TECHNICAL PRODUCT BULLETIN TB-2024-07-01 Rev B

Subject: LD Series Accessory Changes

25LD Tipping Stand

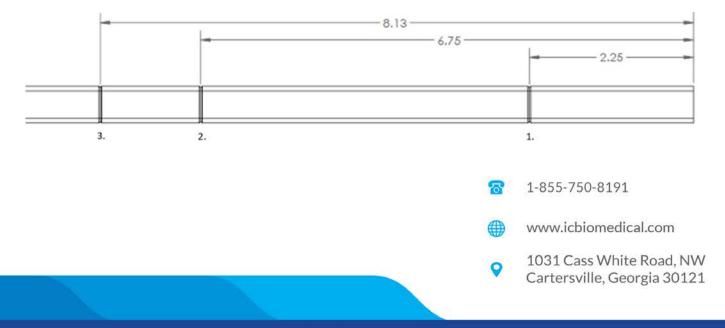
As previously detailed in Technical Bulletin TB-2024-03-01 there have been changes to the LD Series product line with the 25LDB vessel becoming obsolete and replaced by the 25LD. Due to this change the tippling stand, item number D025-8C00 is not compatible with the new 25LD.

- If you require a tipping stand for the older 25LDB with a 15.6" (396mm) outer diameter then please order the original tipping stand, item number D025-8C00.
- If you require a tipping stand for the new 25LD with a 14.8" (376mm) outer diameter then please order the new version tipping stand, item number D025-8D01.
